**AMENDMENTS TO THE DRAWINGS:**

### **REMARKS**

Appl. No. 10/826,272  
Amendment dated April 17, 2008  
Reply to Office Action of November 15, 2007

Fig. 7

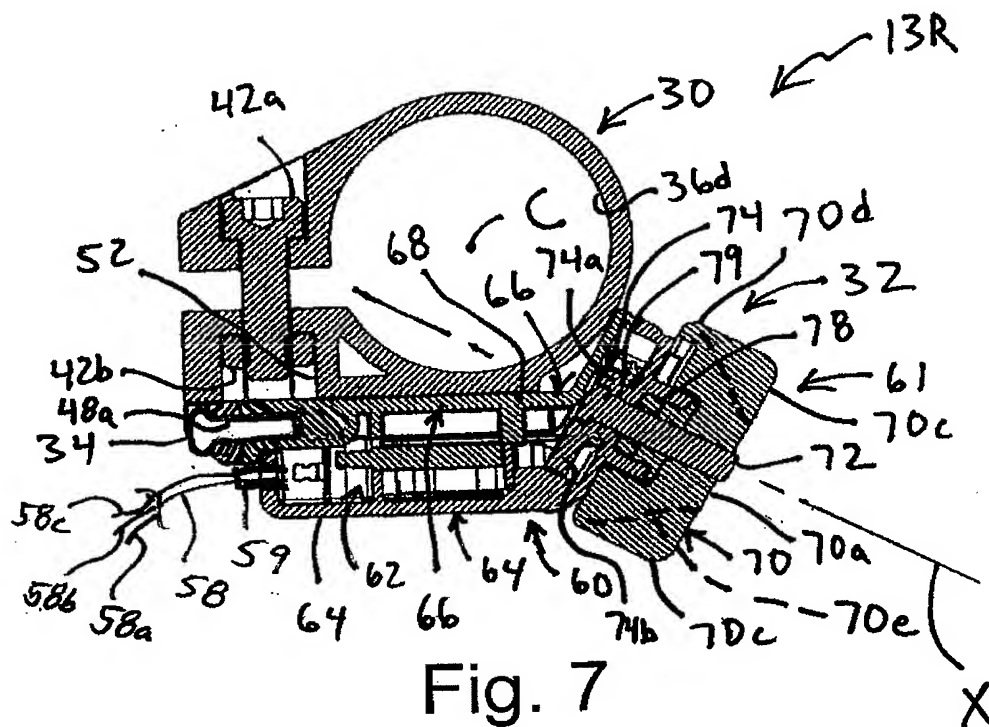
In paragraph 4(a) of the Office Action, the drawings were objected to for allegedly introducing new matter in Figure 7. This objection is respectfully traversed as set forth in the January 15, 2008 Petition under 37 CFR §1.181. Specifically, in the August 2, 2007 Amendment, Applicant added the plane P that is perpendicular to the rotation axis X and passes through the center axis C to Figure 7. Also, the reference character "S" identifying the split was added to Figure 7. See the reproduction of Figure 7 from the August 2, 2007 Amendment below.

In paragraph 4(b) of the Office Action, the Office Action indicates that the changes to the drawings by the August 2, 2007 Amendment were not sufficiently explained. Thus, the changes are now explained. Applicant added the plane P that is perpendicular to the rotation

In paragraph 6 of the Office Action, August 2, 2007 Amendment was objected to for allegedly introducing new matter in paragraph [0064]. This objection is respectfully traversed as set forth in the January 15, 2008 Petition under 37 CFR §1.181. Specifically, Applicant amended paragraph [0064] to state "The pivot axis X preferably intersects the curved mounting surface 36d of the tubular clamping portion 36 such that the operating member 61 is disposed on an opposite side of a plane P from the split S. The plane P is perpendicular to the operating axis X and passes through the center axis C of the transverse portion T of the handlebar 14, as best seen in Figure 7." Adding this language to the specification does not constitute an introduction of new matter. Specifically, such language is clearly supported by the original drawings (e.g., original Figures 3-6) and the original specification, which form parts of the original disclosure. See original Figure 7, which is reproduced below.

Adding this plane P that is perpendicular to the rotation axis X and passes through the center axis C to Figure 7 does not constitute an introduction of new matter. Rather, such a plane was inherently present in original Figure 7, but was merely not yet explicitly identified. In other words, a plane that is perpendicular to the rotation axis X and passes through the center axis C is inherently present in original Figure 7, and thus, is merely being clearly, explicitly identified as plane “P” by the August 2, 2007 Amendment. This change to Figure 7 was made in view of the changes to claim 22 (i.e., the plane and split are set forth in amended claim 22) and in view of an objection in the April 18, 2007 Office Action that “a mating mounting structure” set forth in the claims was not identified with a reference numeral. In other words, based on this prior objection, Applicant believed that the plane P and the split S should be clearly identified in the drawings to avoid a potential objection. In other words, Applicant believes that new identifying information was added to Figure 7, not

axis X and passes through the center axis C to Figure 7. Also, the reference character "S" identifying the split was added to Figure 7.

It is clear from this Figure that *the operating member 61 is disposed on an opposite side of a plane (the plane being perpendicular to the operating axis X and passing through the center axis C of the transverse portion T of the handlebar 14) from the split of the portion 30*. In fact, it is clear from this Figure alone that the operating member and the split lie on opposite sides of many different planes, the plane P merely being one that is easily identifiable because of its arrangement relative to the operating axis X and the center axis C of the transverse portion T of the handlebar 14. Based on the above comments, Applicant respectfully requests that this objection be withdrawn.
